**DESCRIPTION AND MAINTENANCE INSTRUCTIONS**

**MAGNETO SCINTILLA MODEL SB9RN  
VERNIER DRIVE COUPLING REMOVAL**

(This EO replaces EO 15-5A-2B dated 21 Feb 57)

Figure 1

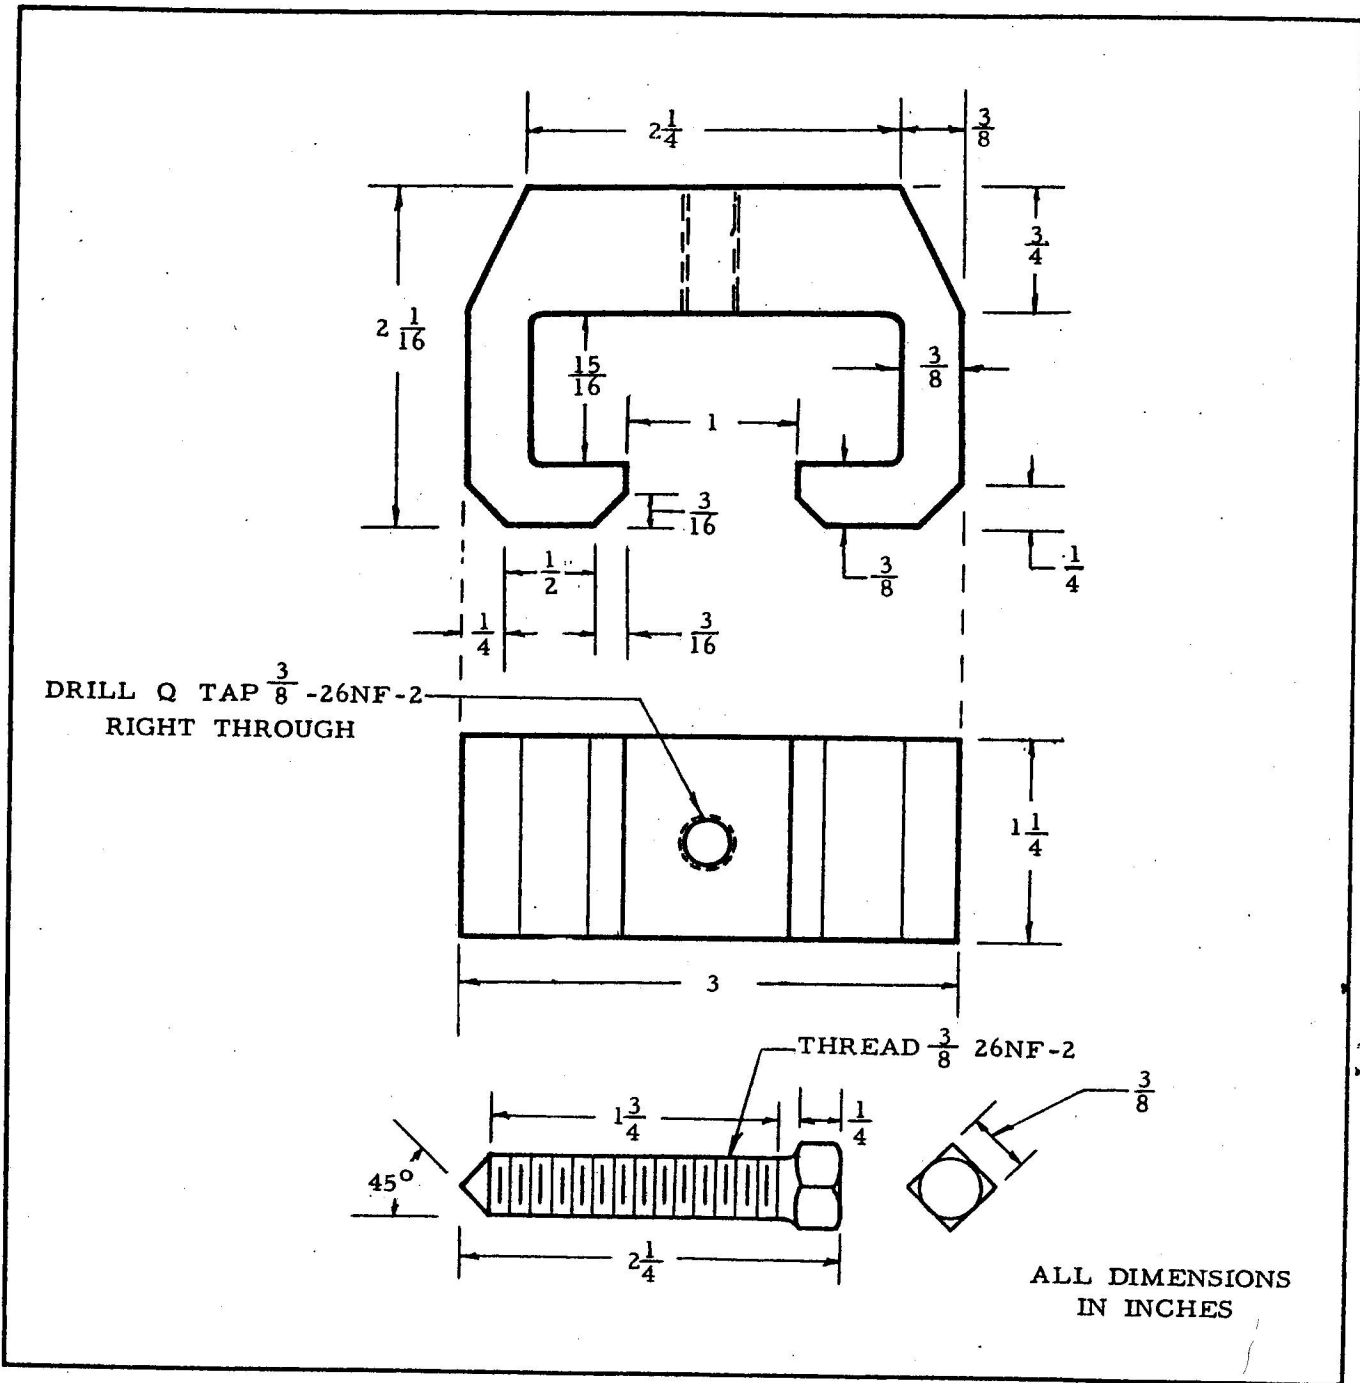
- 1 Contractors Technical Inspection Reports (L53) have indicated that an increasing number of Scintilla model SB9RN magnetos are still being damaged by the operators due to incorrect removal of the Vernier drive coupling gear Part 11048, ie prying off with pinch bar or screw-driver, and hammering when unable to remove by prying.
- 2 In future, when the Vernier drive coupling gear has to be removed, operating units are to ensure a puller is used. The puller is to be locally manufactured in accordance with Figure 1.
